**From:** Iain Robertson [roberti@moray.gov.uk]  
**Sent:** 24 March 2009 12:19  
**To:** diane.anderson@moray.gov.uk  
**Subject:** FW: FW: Access to Consented Wind Turbine

Seren Energy Ltd.		 seren energy	
TITLE:	Myreton Wind Farm	DATE:	03/03/09
CLIENT:	Myreton Renewable Energy Ltd.	SCALE:	1:500
DRAWN:	OP	DRAWING NO.:	MYR030309-1
CHECKED:	GT	OS LICENCE NO.:

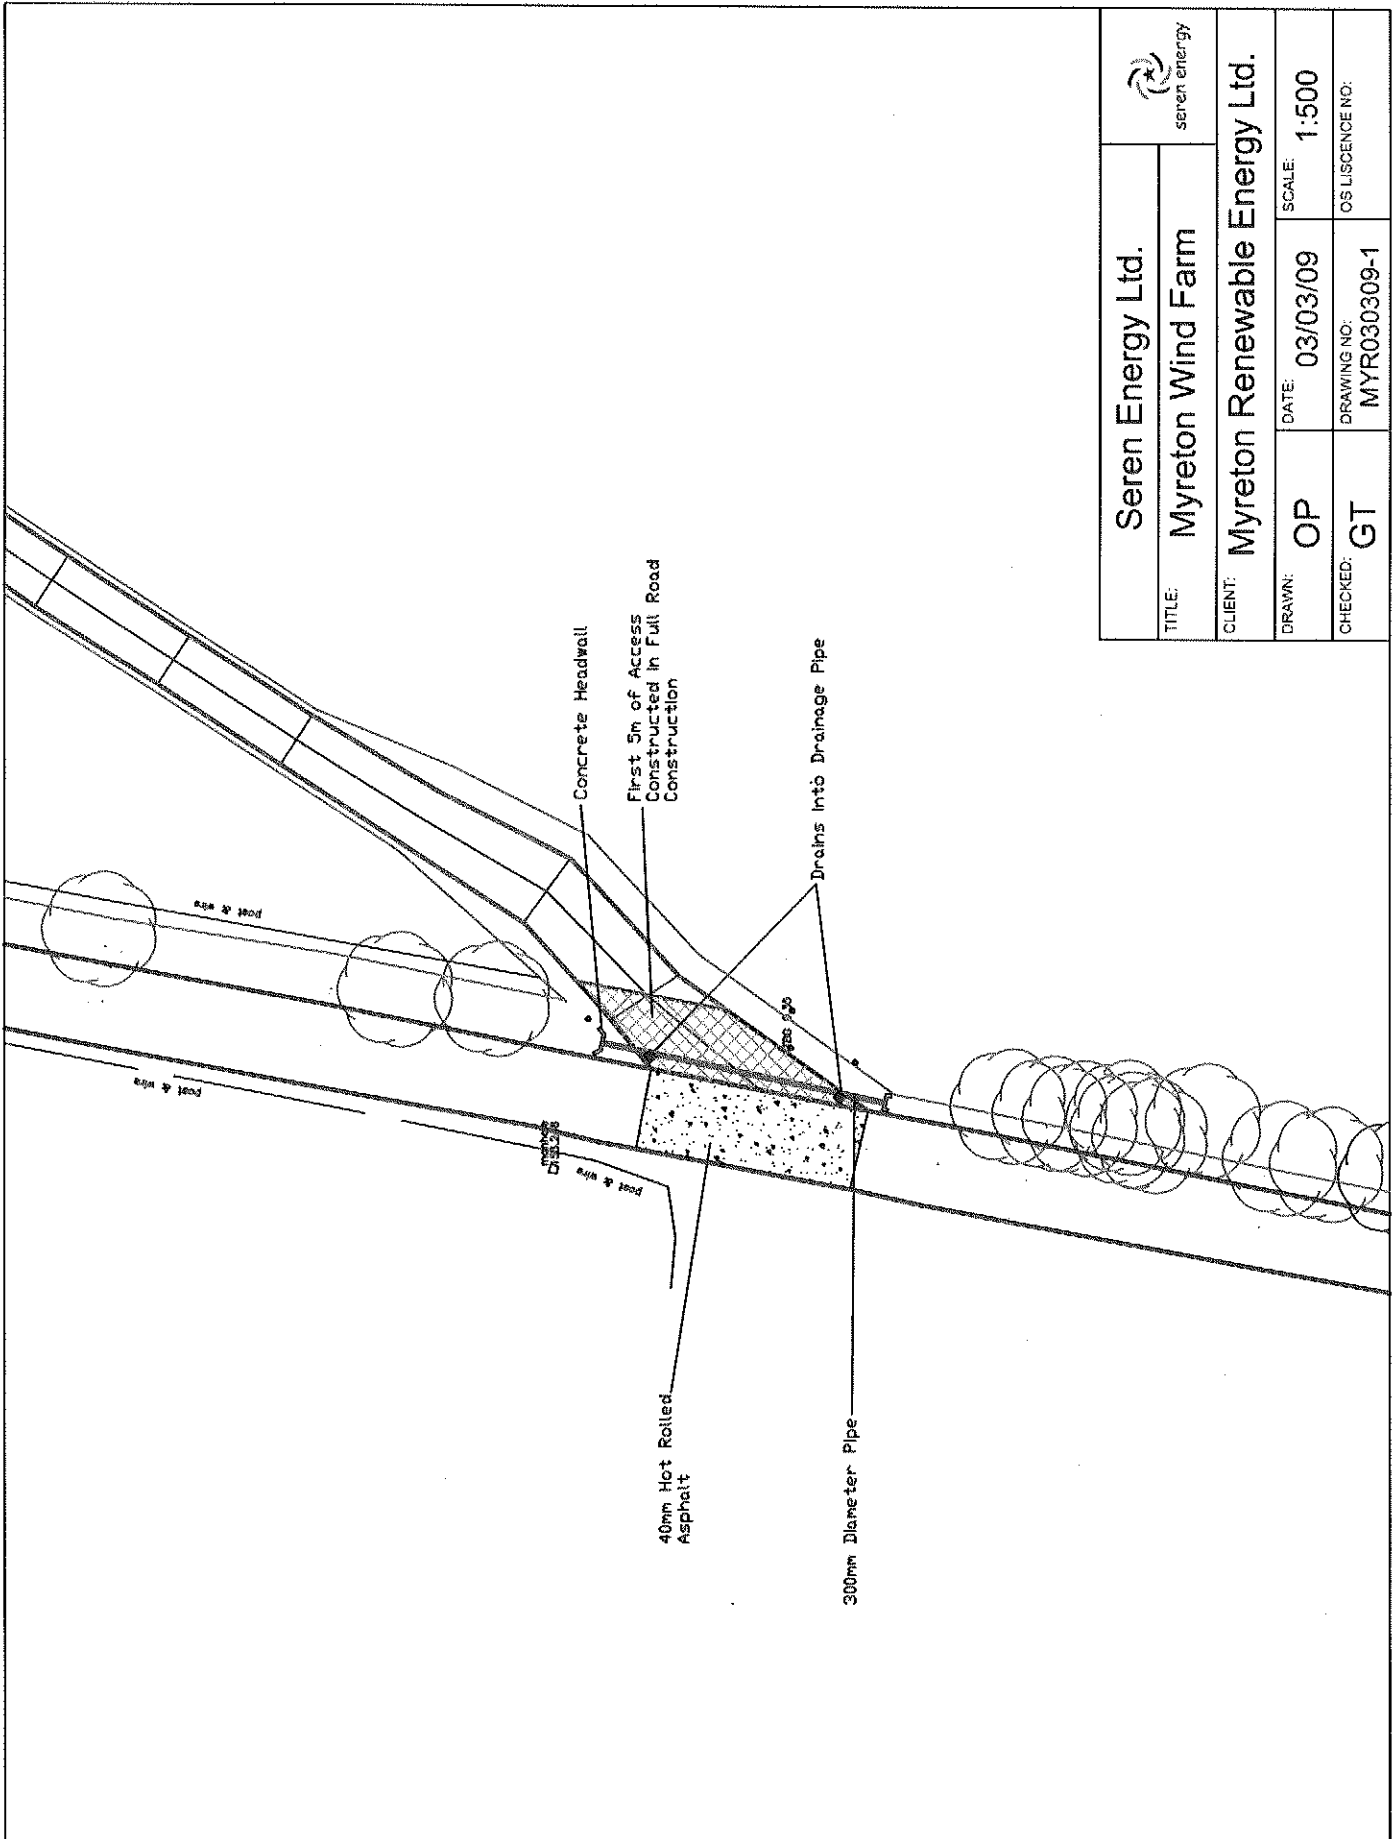
B9018 will require to be overlaid in 40mm thick hot rolled asphalt. Joints to be cut in carriageway for new surfacing to tie in with existing.  
Bitmac level of new access to tie in with new asphalt surfacing on B9018. This detail will not cause a step in the road.

You should show on 1 : 500 scale drawing (Omit contours for clarity):-

1. B9018 surfaced in hot rolled asphalt.
2. First 5 metres of new access constructed in full road construction.
3. Existing ditch piped in 300mm min dia pipe with in situ concrete headwalls at inlet and outlet.
4. What measures are to be put in place to ensure that water does not run from new access onto B9018.

Details of access onto B9018 have not been shown on drawings provided.

Please provide drawings of access so tracking can be checked for units and trailers used to transport turbines and blades to site.

Profile, showing existing and proposed levels, from chainage 0 to 100 metres of service road should be included.

First 5 metres of service road should be constructed in full road construction and surfaced in 75mm thick single course macadam.

B9018 to be surfaced in 40mm thick hot rolled asphalt over its full width over the full width of the new access.

Existing ditch to be piped using 300mm min dia pipe in concrete surround. In situ concrete headwalls to be constructed at inlet and outlet.

Side slopes to be graded/trees removed to provide visibility splays of 4.5 metres x 215 metres in both directions.

Measures to be taken to ensure that water does not discharge from service road onto B9018.

Following the advice in your e mail sent on the 24th February i have altered and updated the 1:500 scale plan of the proposed access track road opening for the Myreton wind turbine access. This is attached to this e mail. If you require any further updates, please let me know.

To prevent water running off the new access track onto the road, the lower section of the track will be convex in shape and there will be two drains at its end on either side, to drain the run off into the drainage pipe below. Another feature which can be added if you feel necessary would be a slightly raised curb stone running the entire way across the join between the road and the start of the access track. This will divert any water to the drains at the edges. Please let me know if you feel this measure will be necessary as well as the drains.
